SUBJECT: Forwards proposed mods to restricted area boundary, per
 830120 telcon. Mods to be incorporated into FSAR Amend 29.

Subject: NUCLEAR PROJECT NO. 2
MODIFICATIONS TO RESTRICTED AREA BOUNDARY

WASHINGTON PUBLIC POWER SUPPLY SYSTEM
NUCLEAR PROJECT NO. 2

OVERALL SITE PLAN

Figure 2.1-3

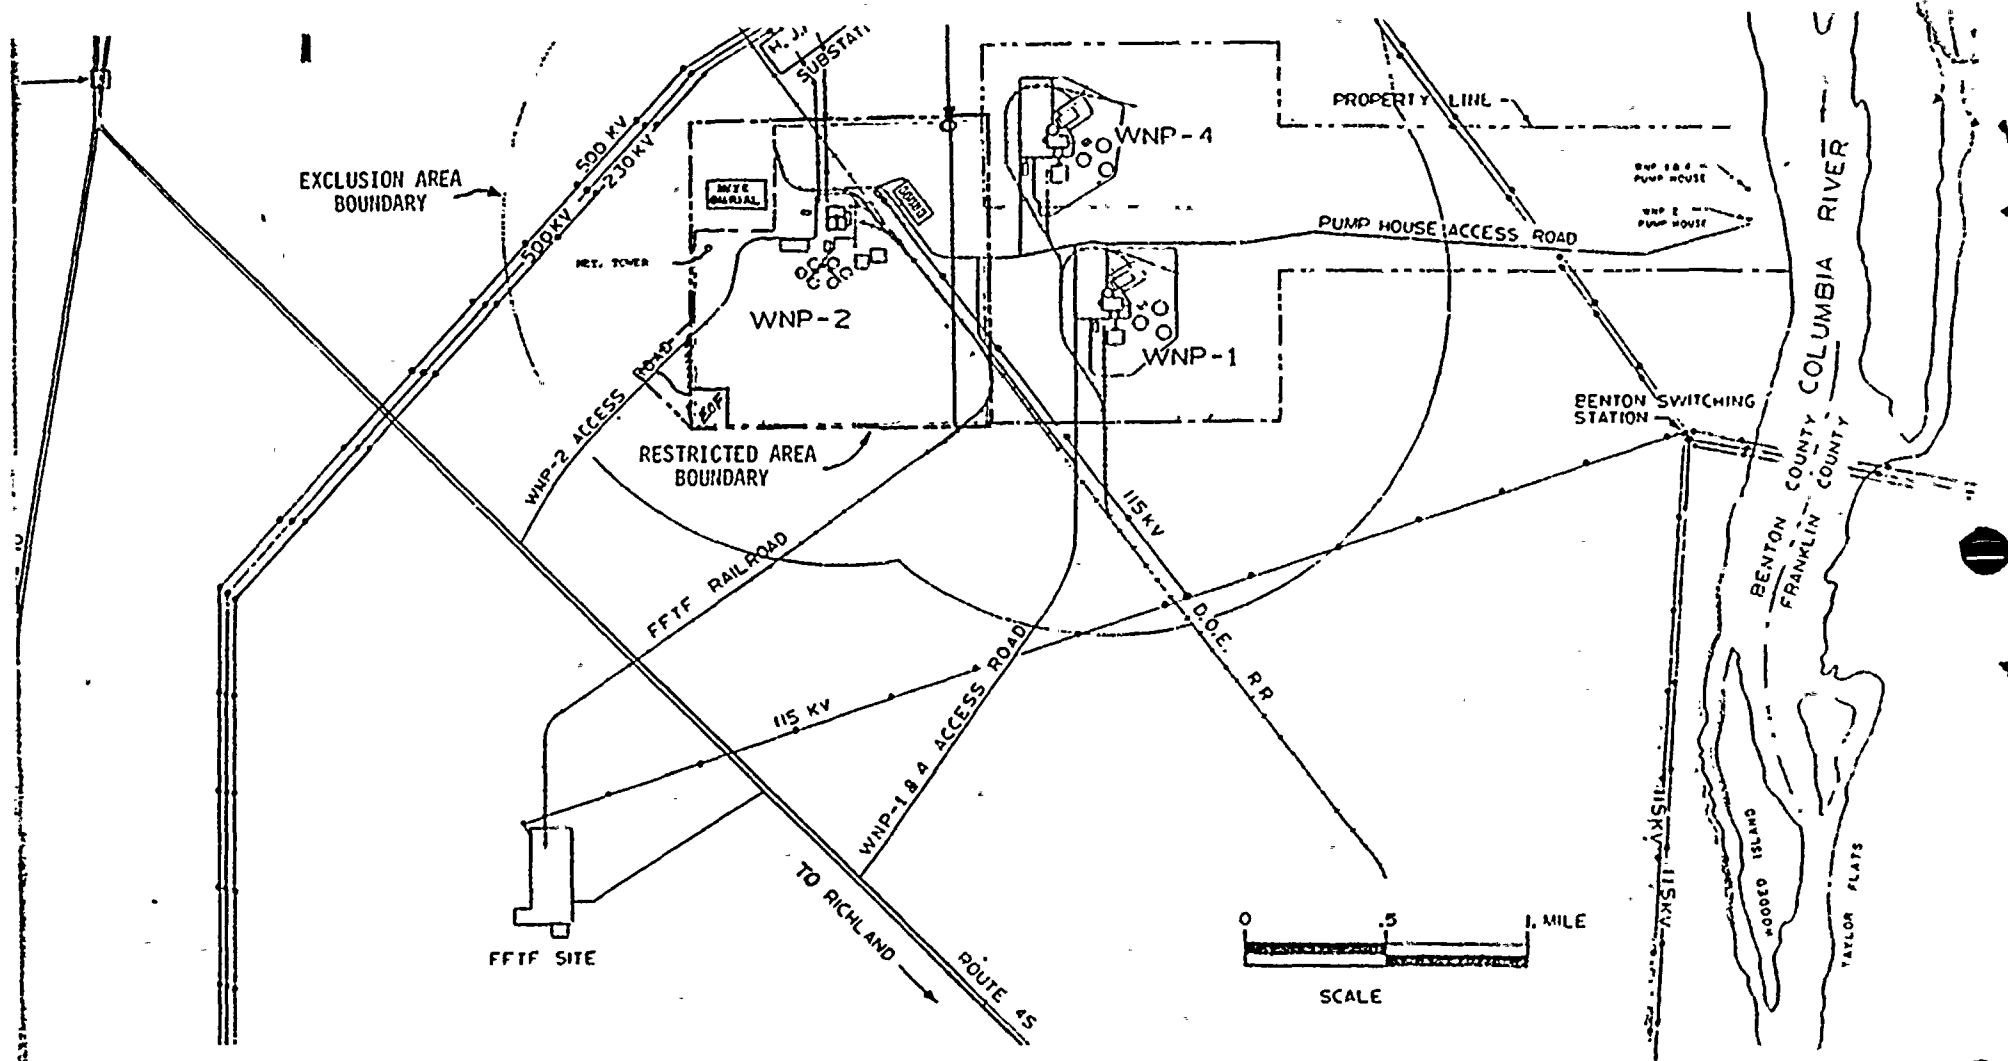
Per telephone conversation between Messrs. R. Auluck (NRC) and R.M. Nelson (SS) on January 20, 1983, enclosed is a reduced copy of Figure 2.1-3 for your review and concurrence. This figure indicates our proposed modifications to the restricted area boundary surrounding WNP-2.

The subject modifications ~~will~~ be incorporated into FSAR Amendment No. 29.
will
